Sheet: /TPS631000 Power Regulation/
File: TPS631000_PowerRegulation_v2.kicad_sch

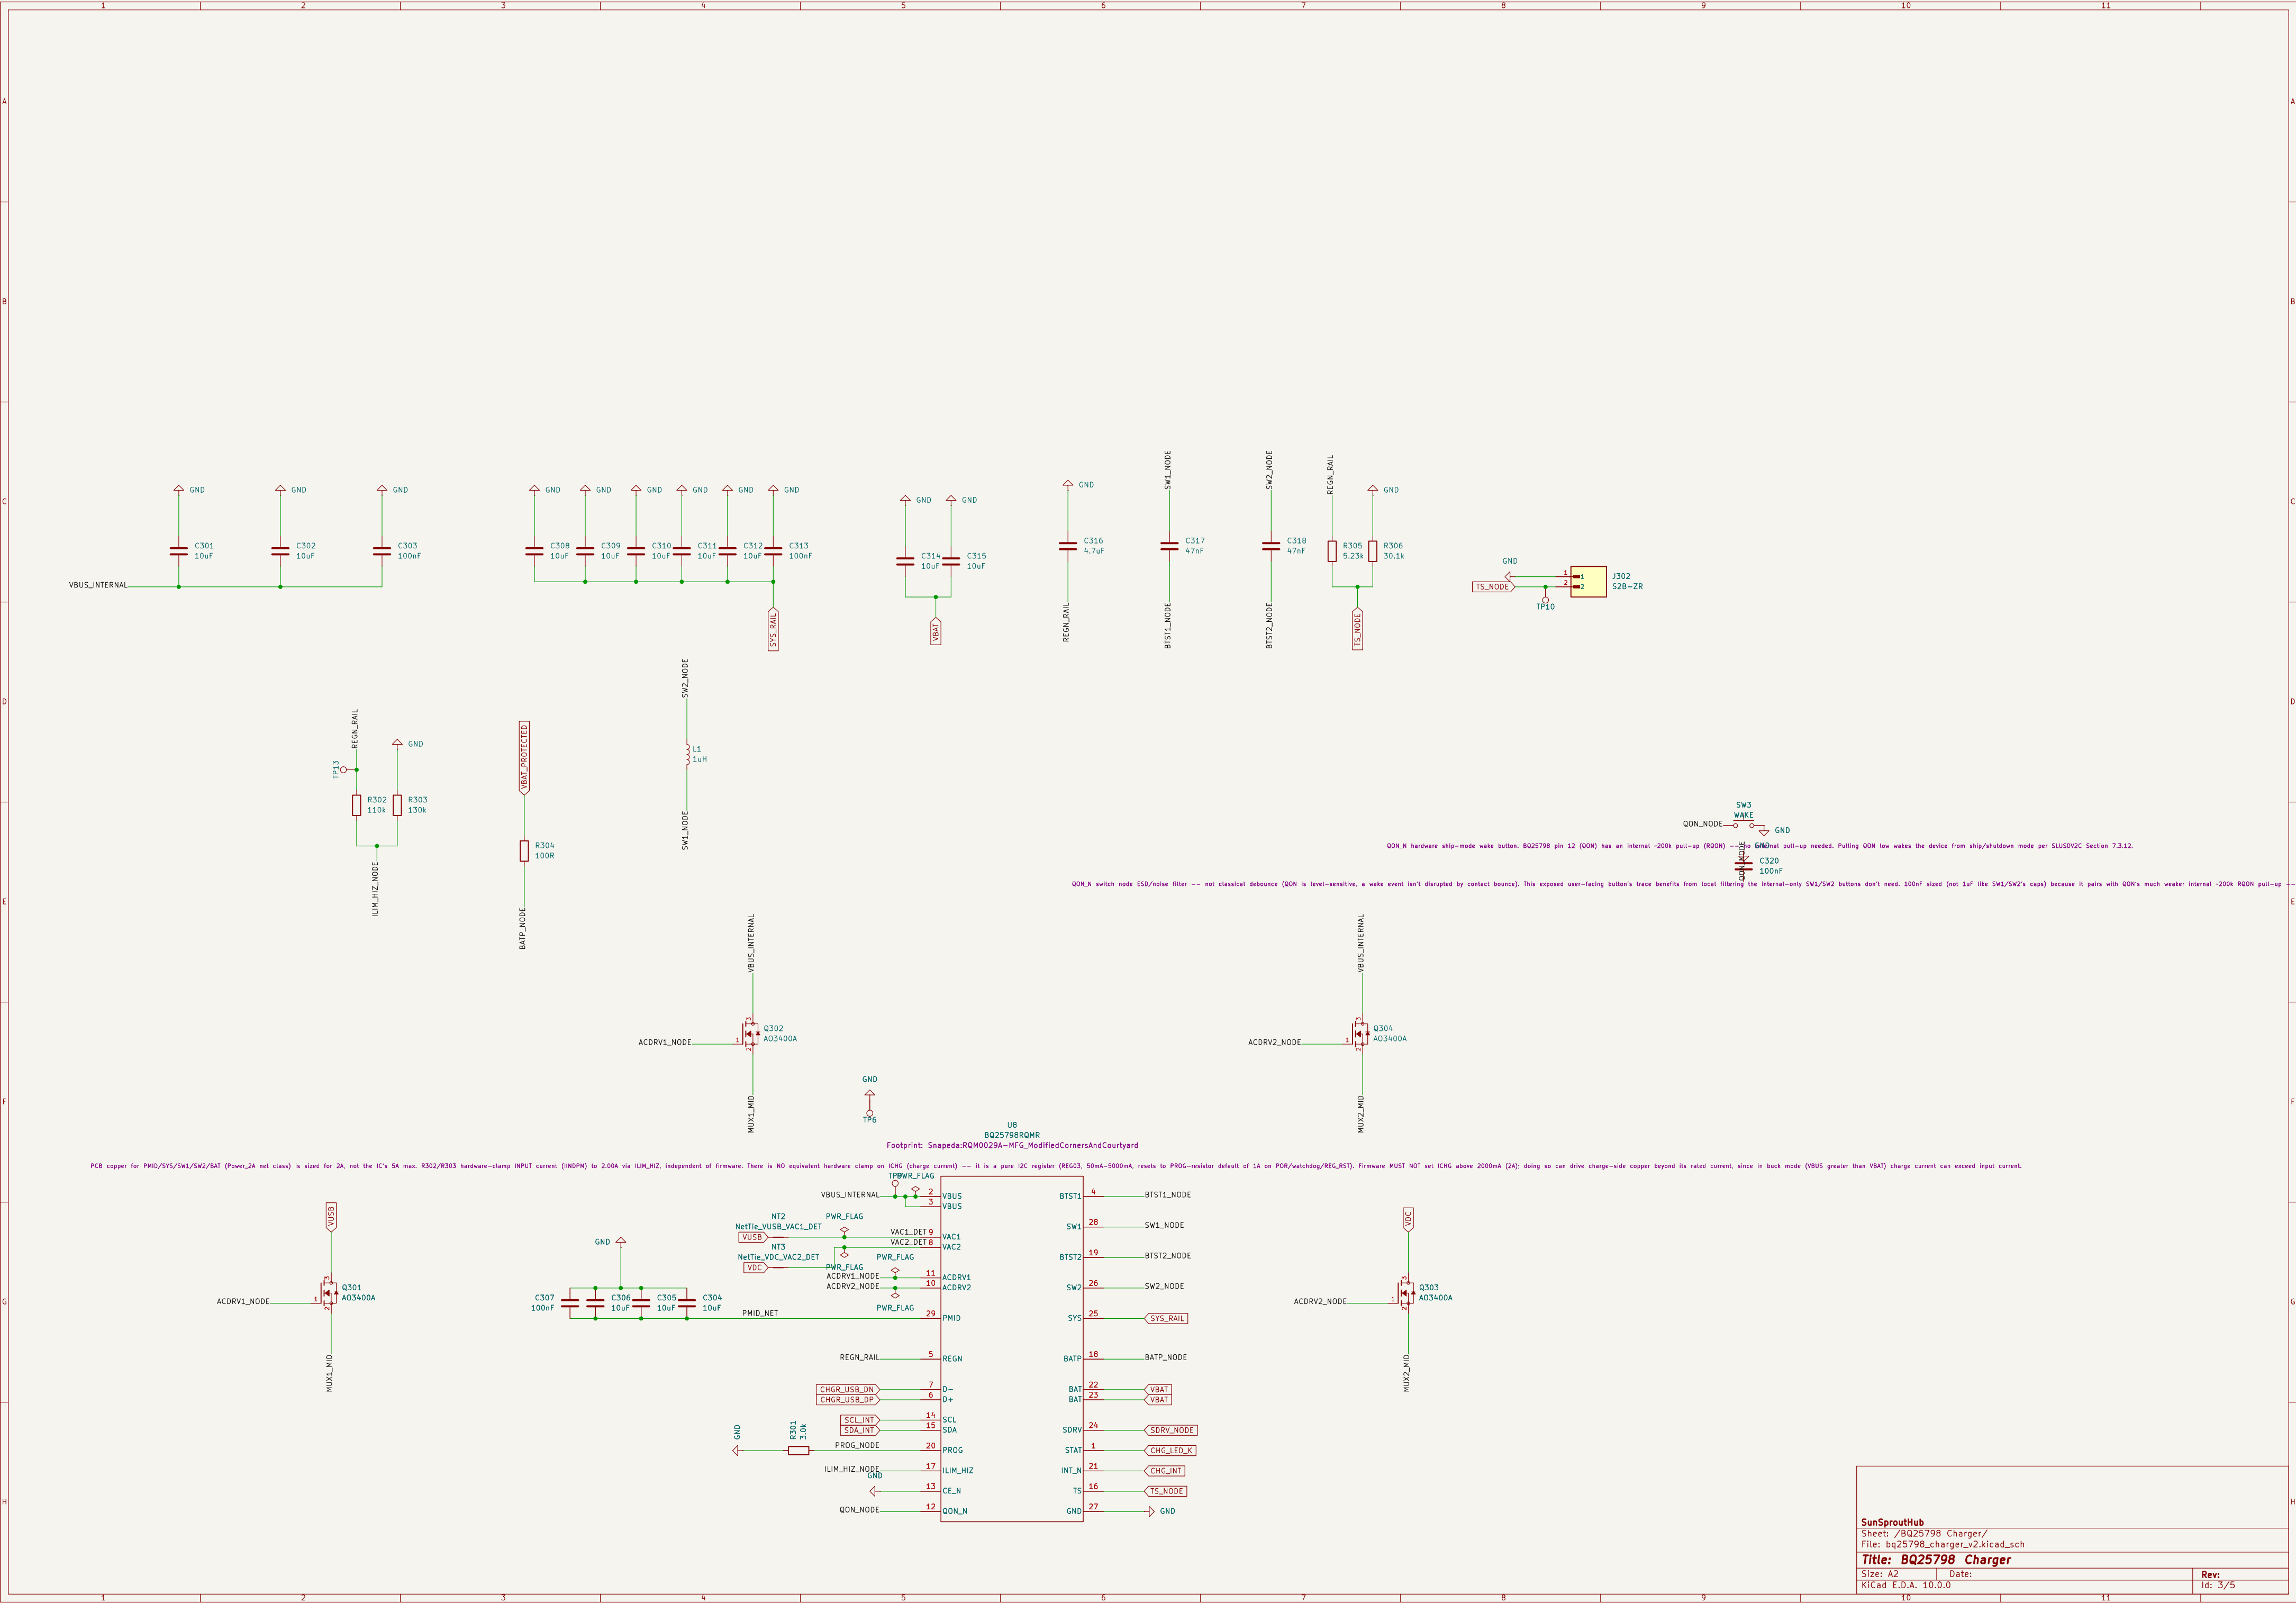
Replaces BQ27427XZFR: BQ27427/BQ27426 have zero LiFePO4 chemistry-profile support (confirmed against datasheet -- only 4.2/4.35/4.4V Li-ion profiles exist). BQ34Z100 explicitly supports Li-ion and LiFePO4. Architecture changed from BQ27427's high-side integrated 7mOhm shunt to a low-side external sense resistor (R60 on the main sheet, in series between the true battery- terminal and system GND) -- SRP/SRN Kelvin-sense across R60.
